**EPA REGION 6 ANNOUNCES THE COMPLETION OF THE DRAFT FINAL
REMEDY SYSTEM EVALUATION (RSE) REPORT**

**HOMESTAKE MINING COMPANY SUPERFUND SITE
CIBOLA COUNTY, NEW MEXICO**

RE: Transmittal of Draft Final Remediation System Evaluation for the Homestake Mining Company

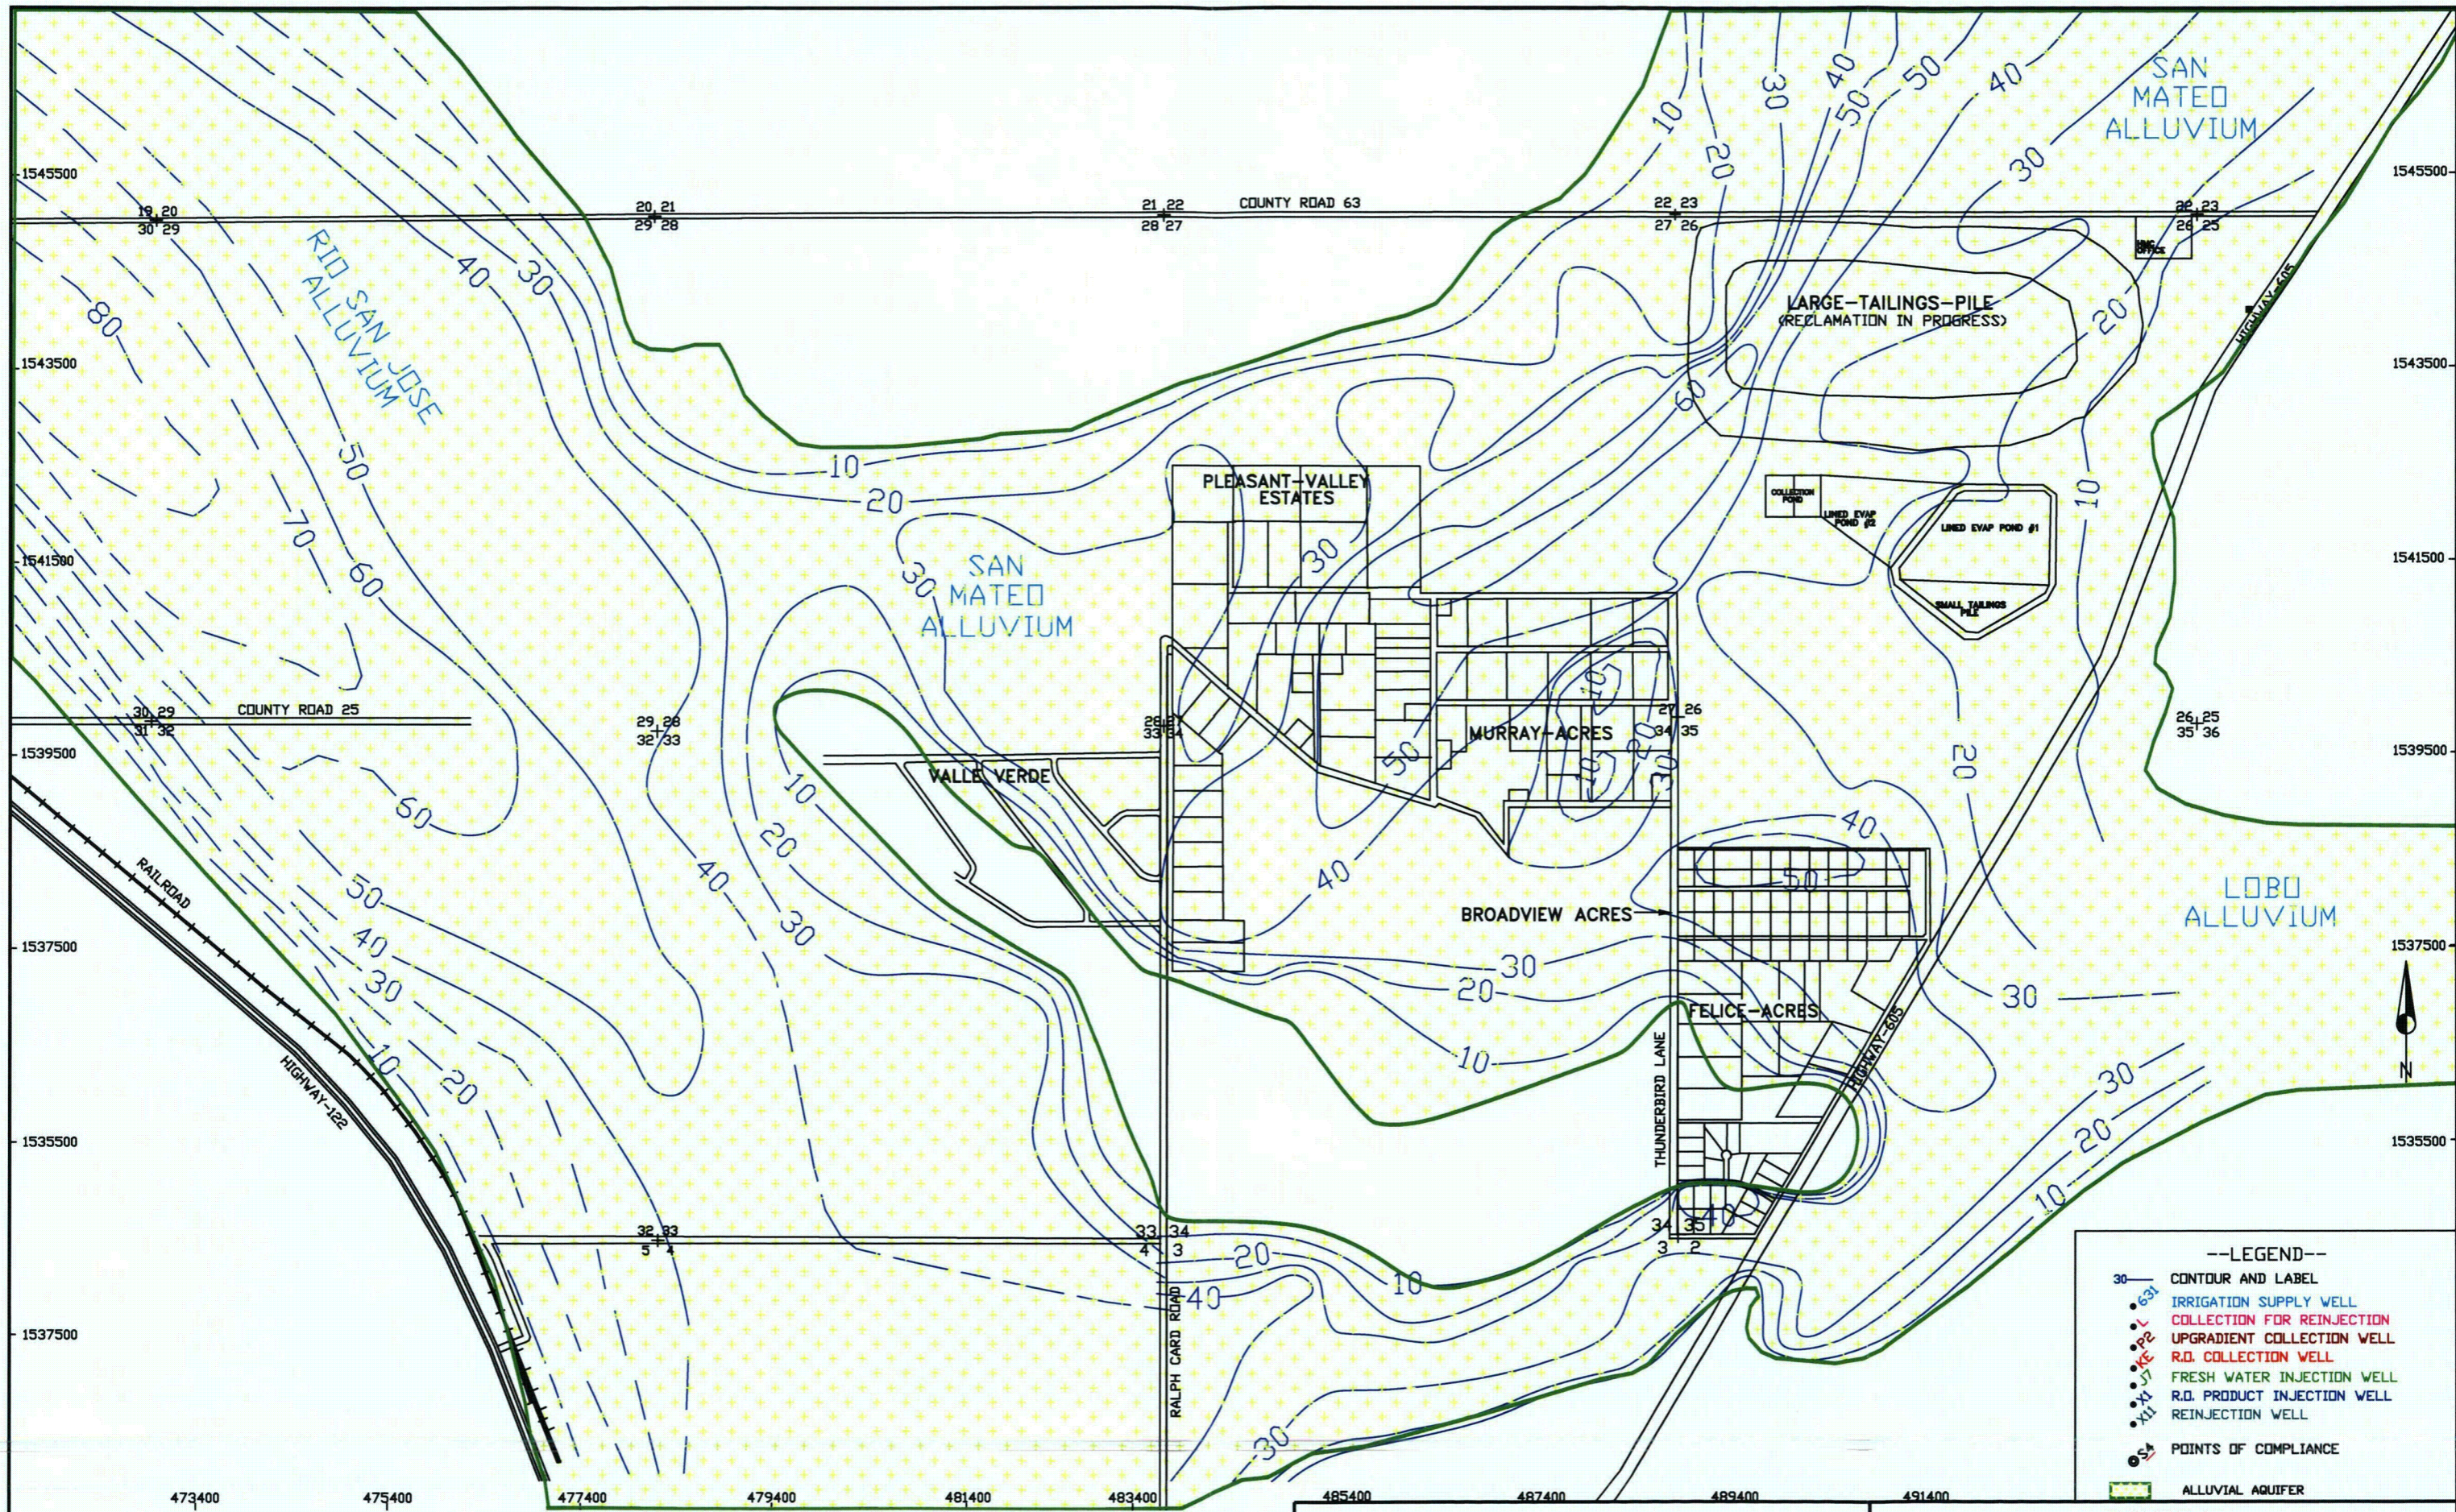
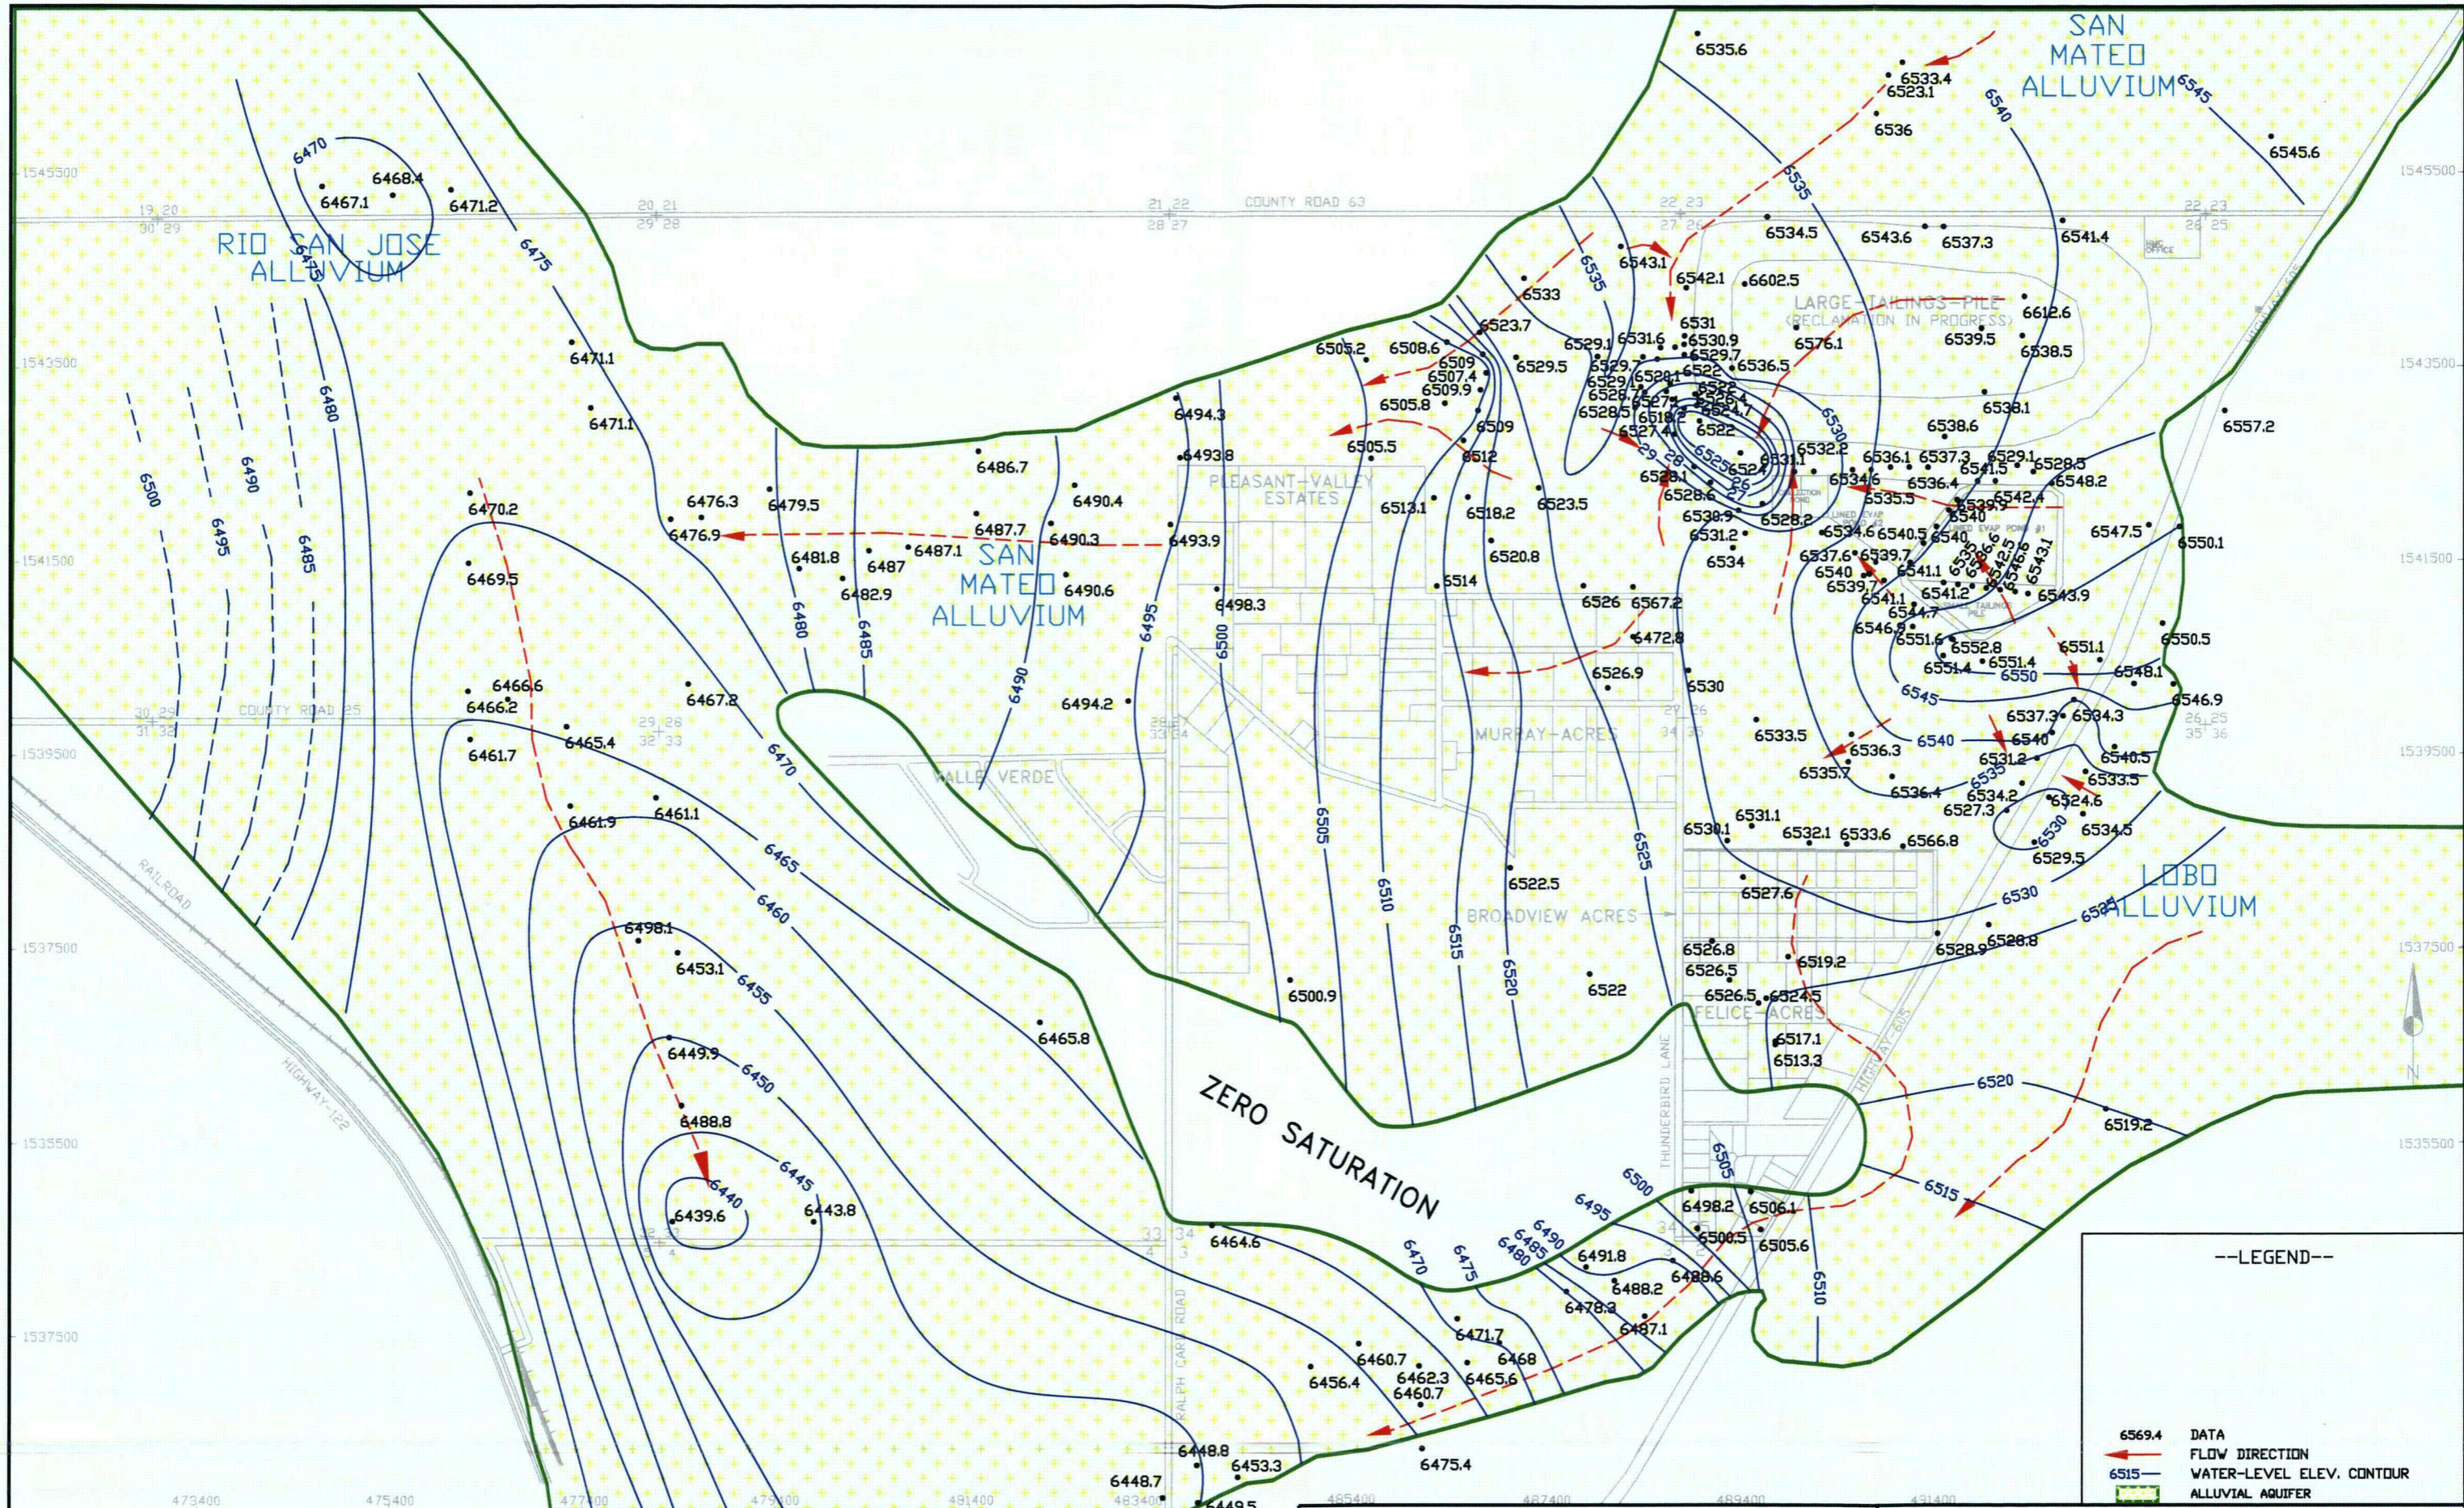
<p>Felice Acres is detached from the main plume (Figure 4.3-53), what transport mechanisms caused impacts in the Middle Chinle (Figure 6.3-14) and Lower Chinle (Figure 7.3-8) aquifers. These issues could result in a revised CSM.</p> <p><u>Response:</u> Agree. Language will be added throughout the Final Report to better describe the mechanisms by which the Chinle Aquifers are contaminated. Note that Figure 4.3-35 does not depict a detachment of the plume but demonstrates where the plume concentration is below the NRC action level (refer to Section 3.3).</p>	
3	<p>Consider alternatives for hydraulic control that may reduce evaporative demands. The current approach of injecting >1,000 gpm of San Andres aquifer water into the alluvial aquifer (for hydraulic control) likely adds a significant amount to the evaporative demand at the site (b/c it is assumed that some injected water is recaptured by the extraction wells and eventually sent to the evaporation ponds). Since one of the limiting factors at the site is evaporation capacity, it may be worthwhile to look at reducing the San Andres injection flow rate and using extraction wells alone (or other capture techniques) rather than injection/hydraulic mounding to achieve capture. The trade off of the two approaches can be evaluated using formal hydraulic and or transport optimization techniques such as MODMAN (see epa.gov/optimization for more information) or through manual approaches using flow and transport modeling without mathematical optimization. This process may “free up” evaporative capacity of the current system.</p> <p><u>Response:</u> The use of San Andres Aquifer water does not significantly affect the evaporative demands of the site. The primary source of water going to the evaporation ponds (71% or 121 gpm) is the Large Tailings Pile flushing program. The remaining 29% (49 gpm) going to the evaporation ponds comes from the Alluvial Aquifer after RO treatment. This water is primarily re-injected Alluvial Aquifer water and Chinle Aquifers water. This amount is only 4% of the total amount of San Andres Aquifer water being pumped into the Alluvial Aquifer for hydraulic control.</p> <p>It is agreed that independent modeling might assist evaluation of alternative pumping approaches. The effort necessary to conduct independent modeling involves a robust approach involving multiple aquifers including vertical communication between the aquifers. Independent modeling was not a part of this RSE.</p>	EPA (Yager)

FIGURE 4.3-83. SELENIUM CONCENTRATIONS FOR WELLS 631, 644, 851, 862, 864 AND 869.

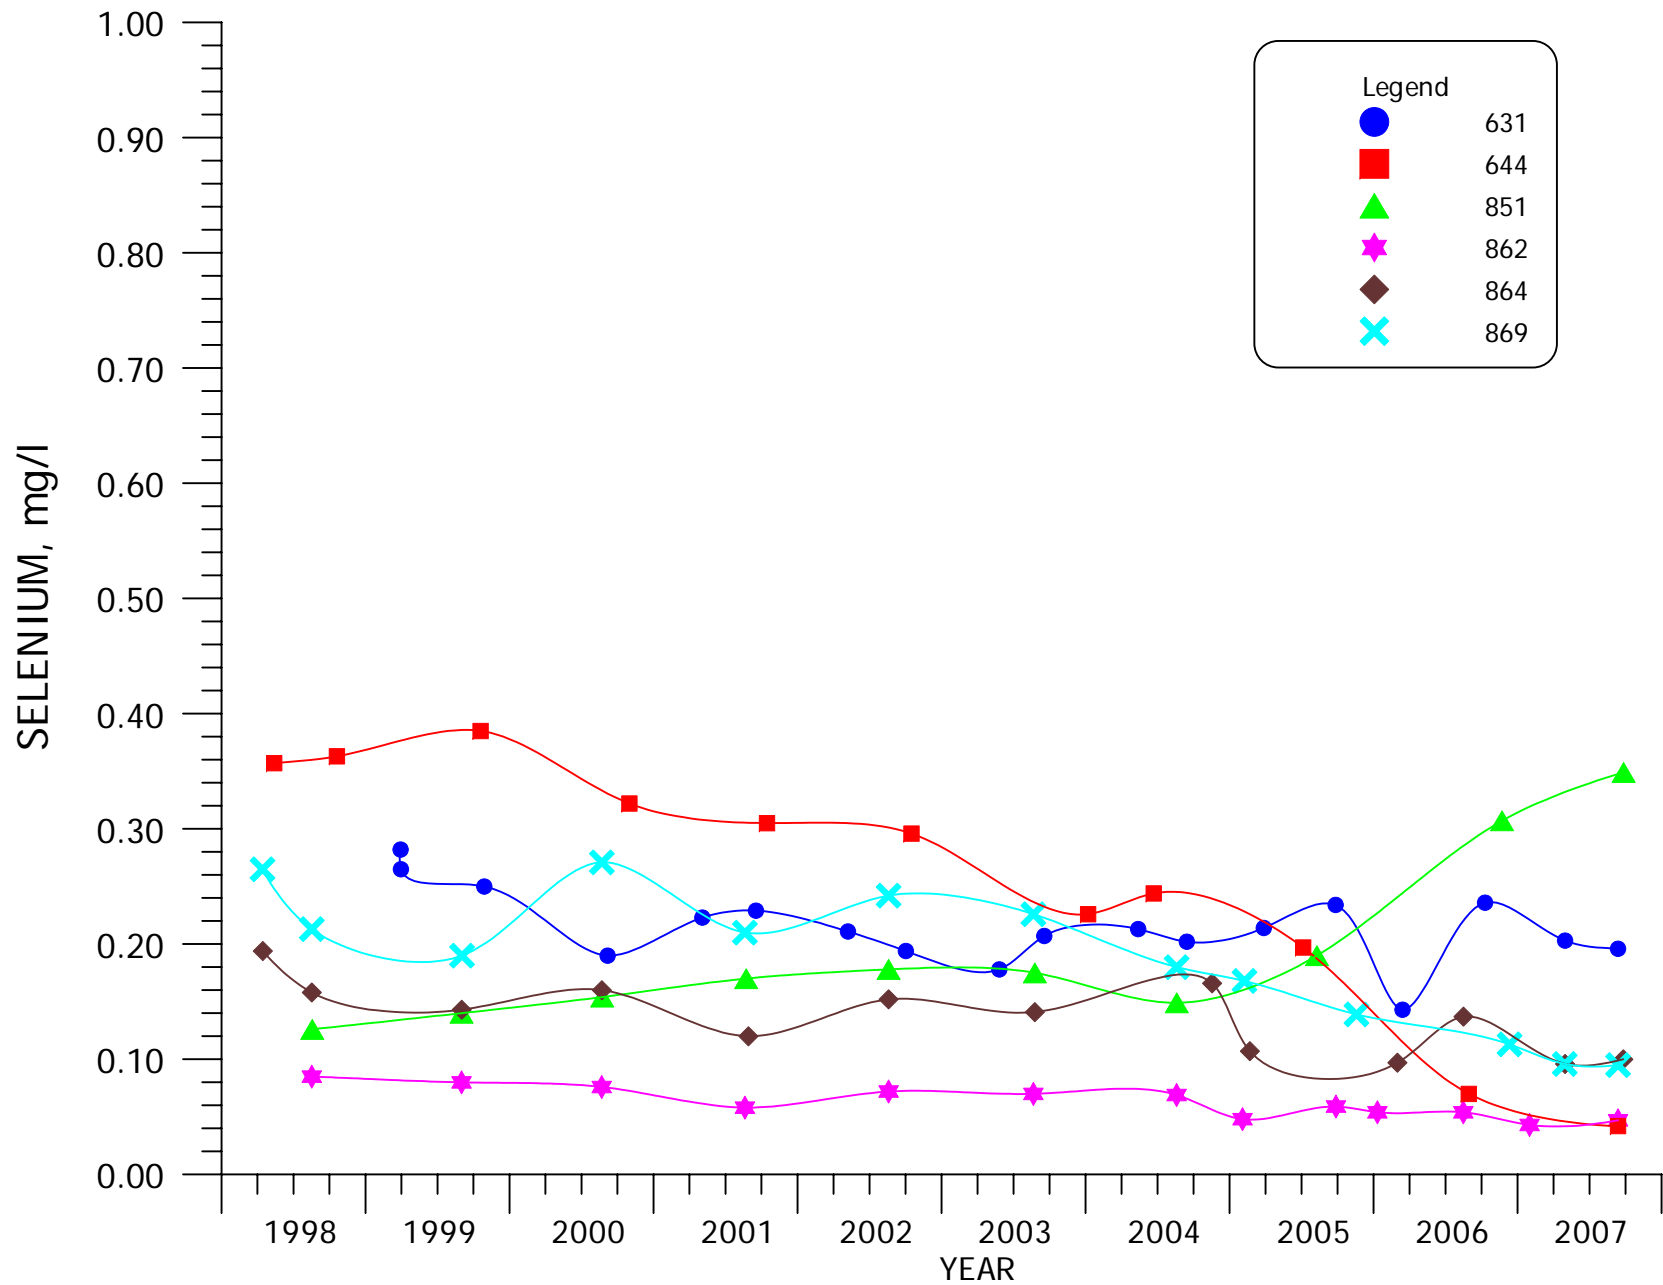
20	<p>Section 1.5.3.1, page 8. The last two sentences of this section refer to Figures 4.3-78 and 4.3-83 and state that the figures show decreases in uranium concentrations. Please revise “uranium” to “selenium” in these sentences. It appears that Well 851 has shown increased Se concentration in 2006 and 2007 and revise the last sentence accordingly</p> <p><u>Response:</u> Agree. Corrections will be made.</p>	EPA (USACE Hearty)
21	<p>Page 10, Section 1.5.4: Suggest that the document provide quantitative evaluations of soil contamination due to crop irrigation with contaminated groundwater and bioaccumulation in livestock due to feeding with hay irrigated with contaminated groundwater.</p> <p><u>Response:</u> Agree, however, no information was available to the RSE Team to provide quantitative evaluations with regard to soil contamination or bioaccumulation of metals associated with the irrigation program.</p>	EPA (USACE Mao)
